NRC DOCKET NUMBERS 50-424 AND 50-425
CONSTRUCTION PERMIT NUMBERS CPPR-108 AND CPPR-109
VOGTLE ELECTRIC GENERATING PLANT - UNITS 1 AND 2
SER CONFIRMATORY ITEM 44: PROCEDURES GENERATION PACKAGE

In the SER your staff requested to review the VEGP EOP's deviations from the ERGs. Enclosed are the deviations noted in our review along with the appropriate justifications.

OPERATIONAL LIMITS CURVE F-0.4

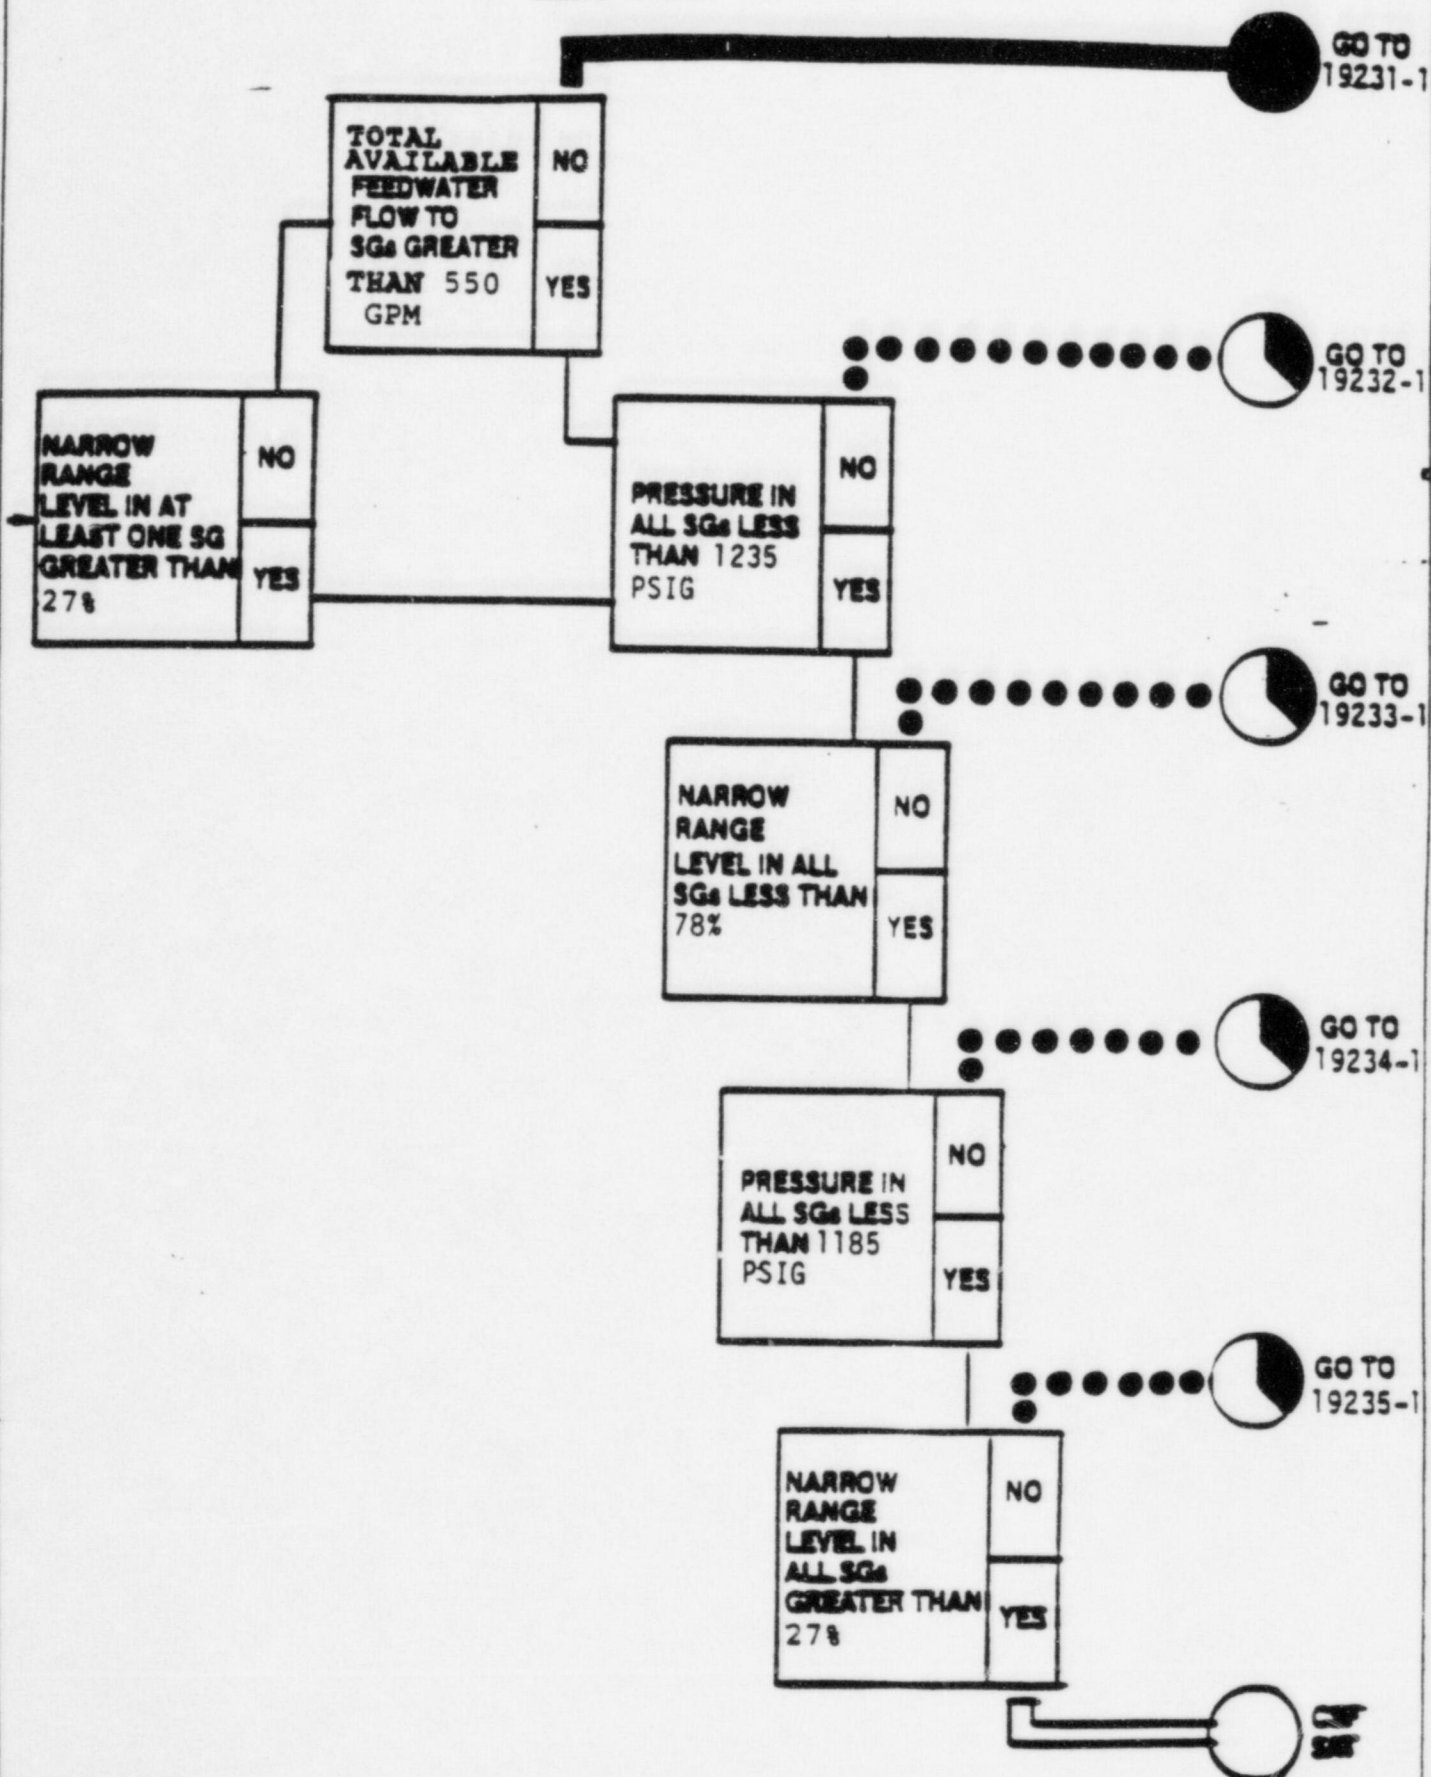
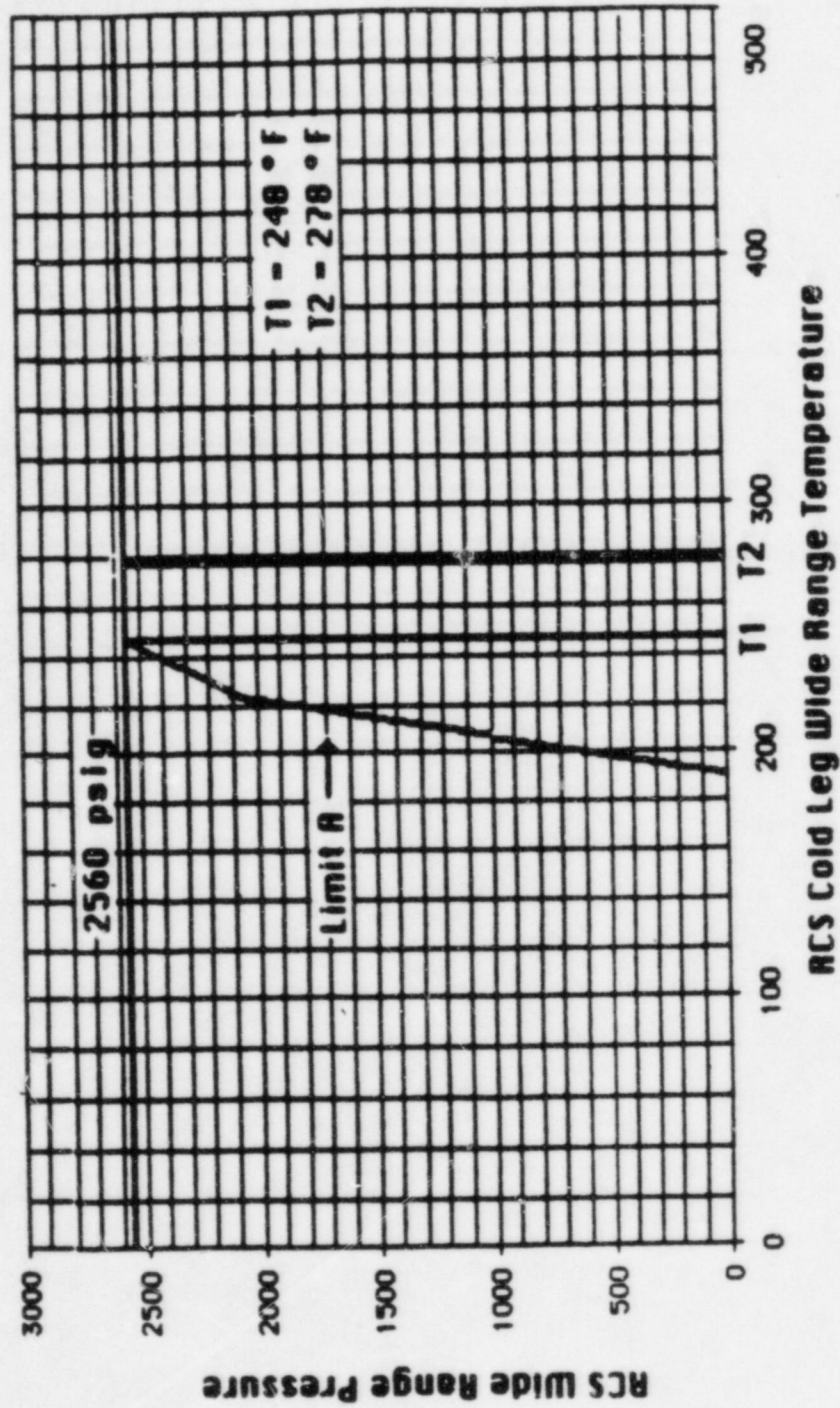
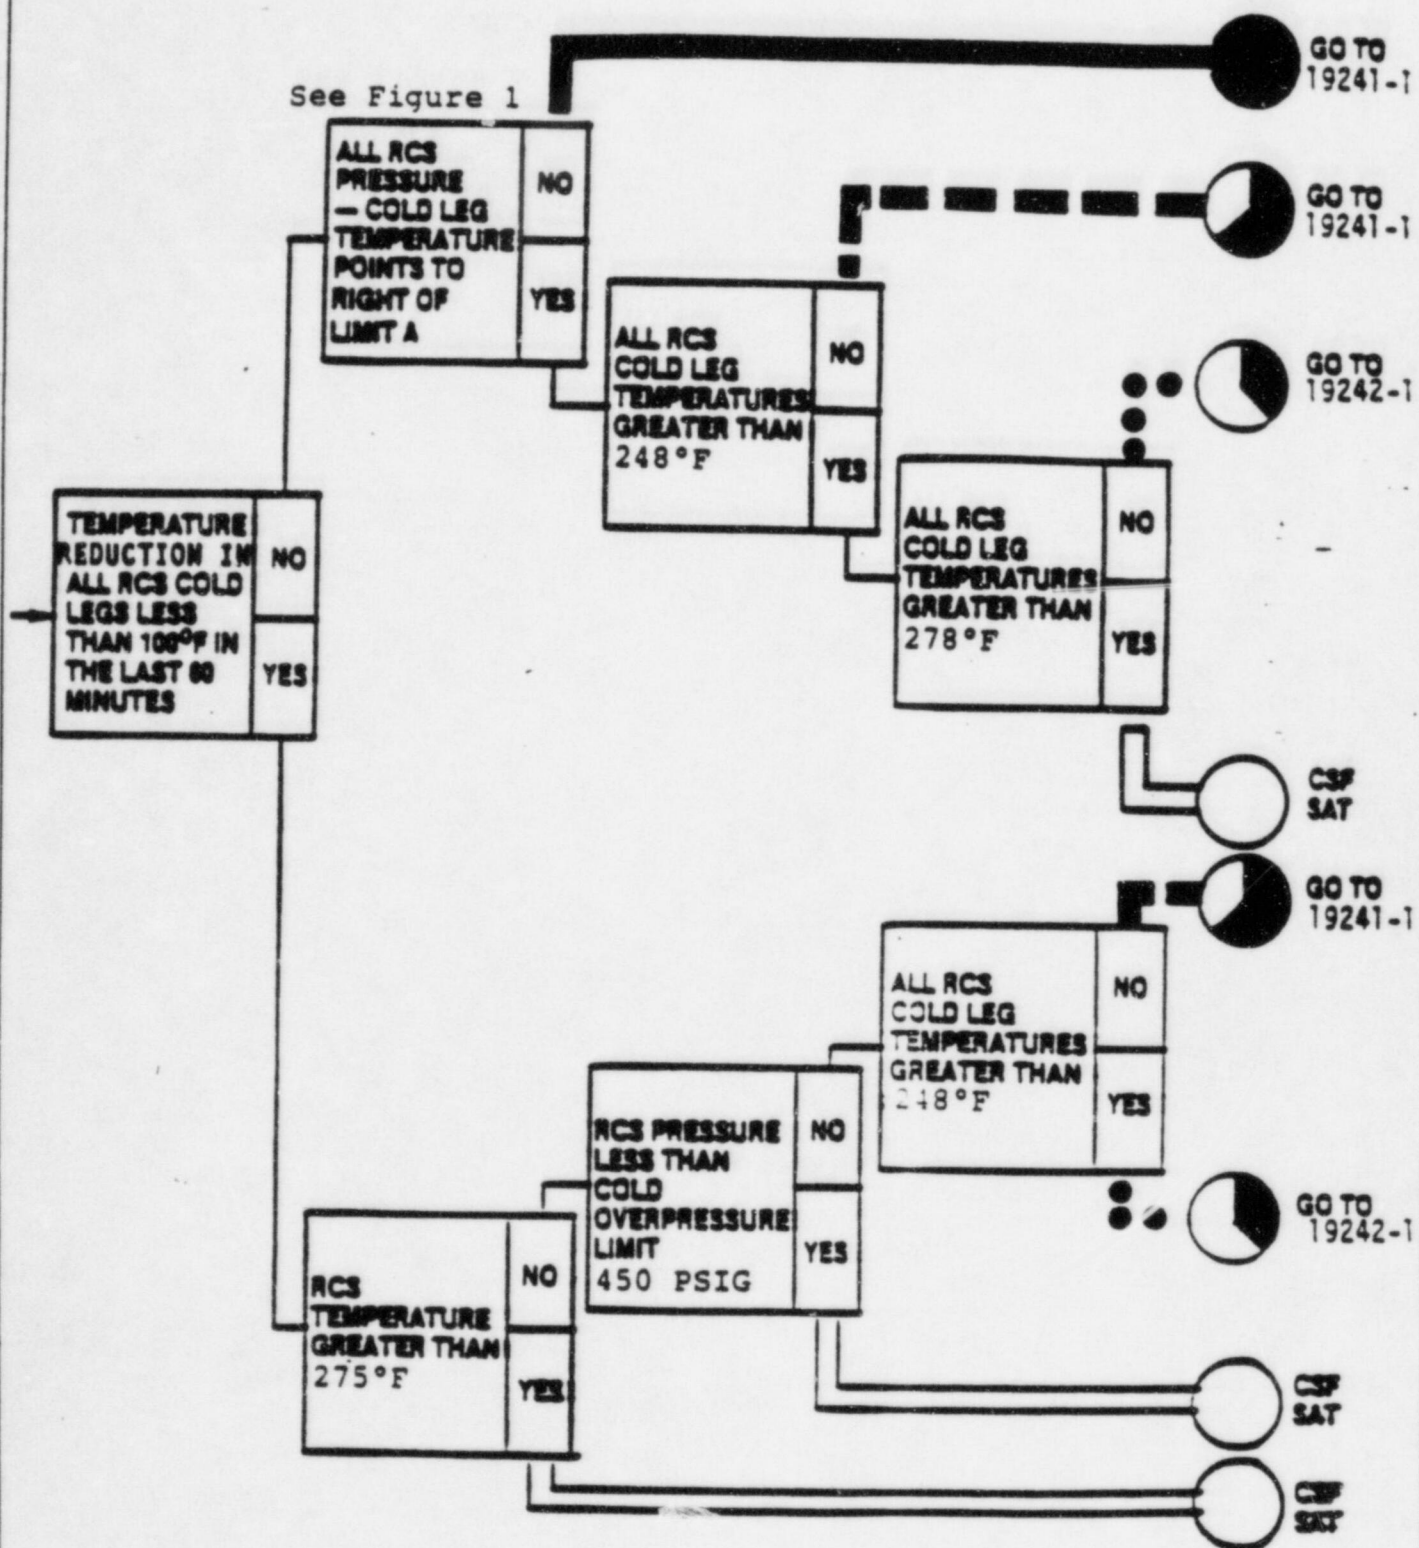
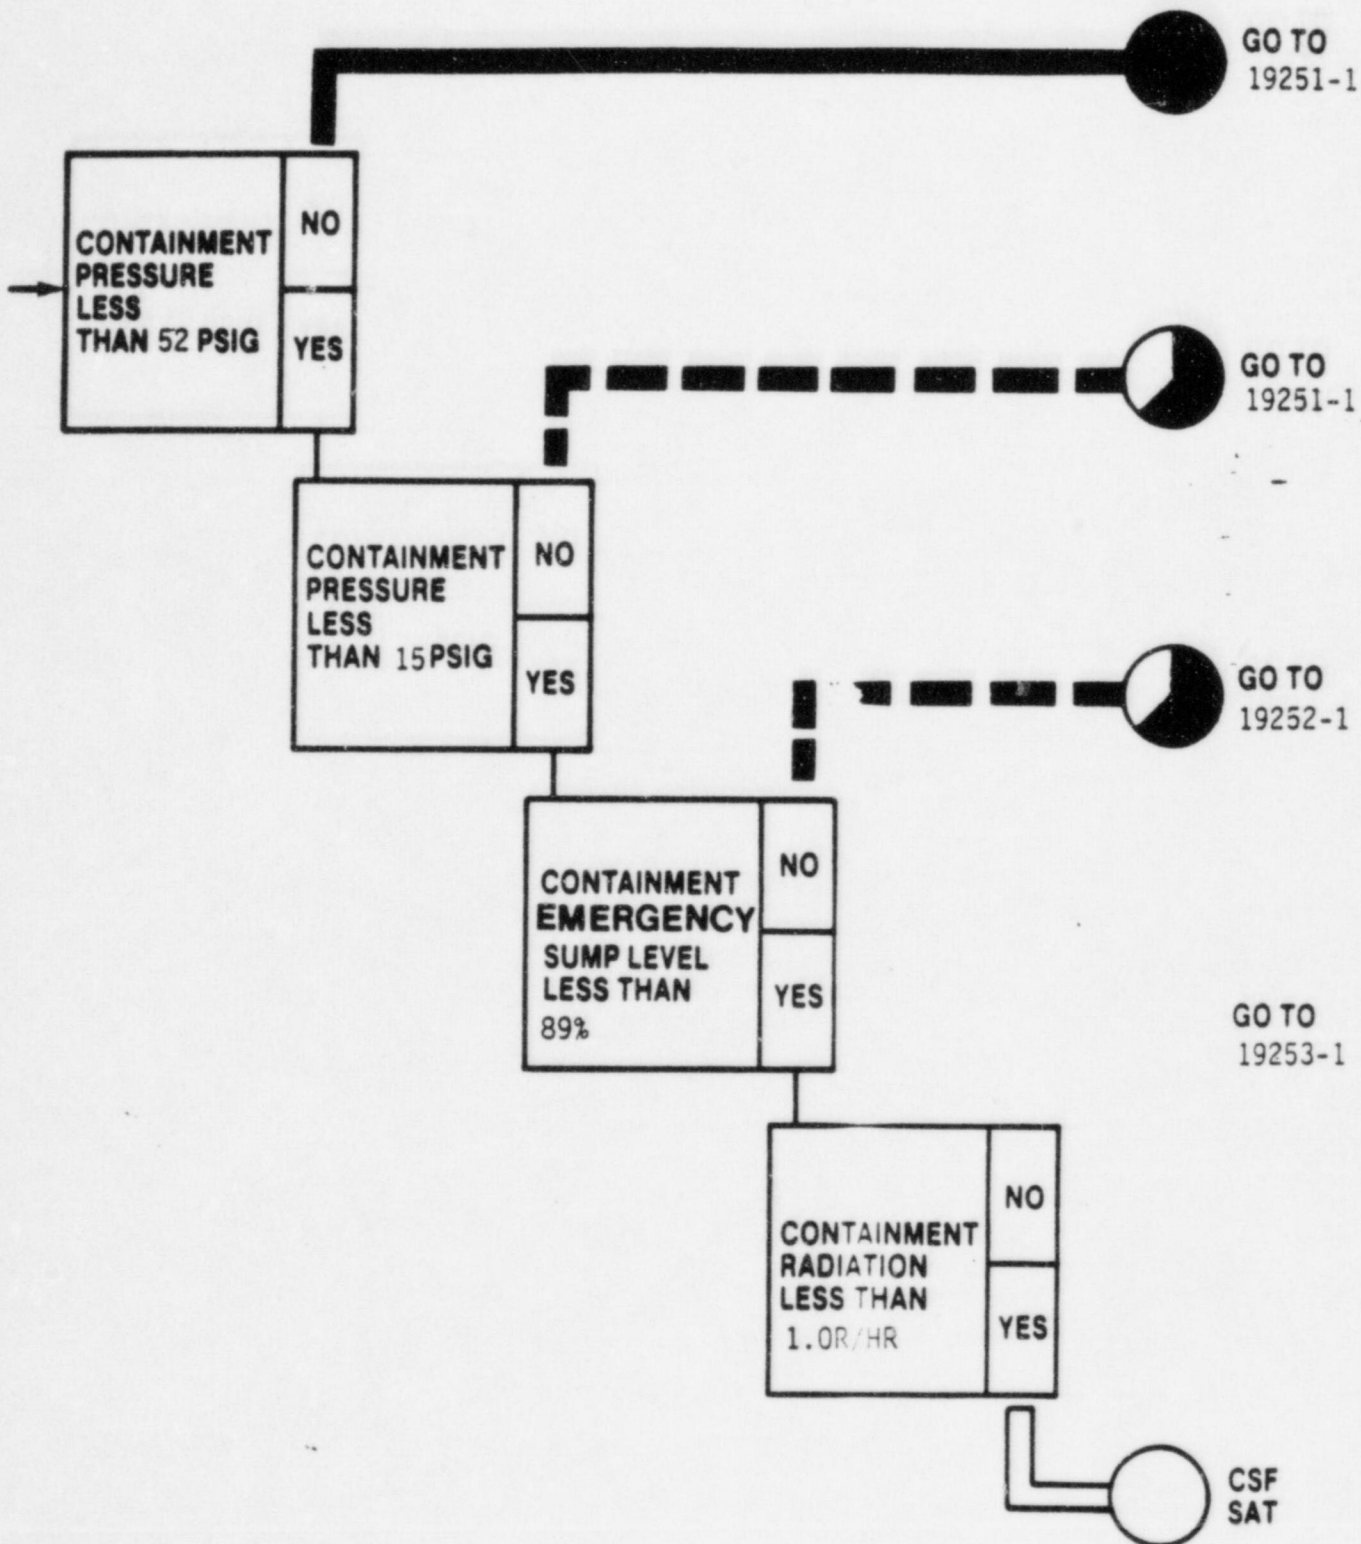
Plant specific
values and VEGP EOP
identification was included.
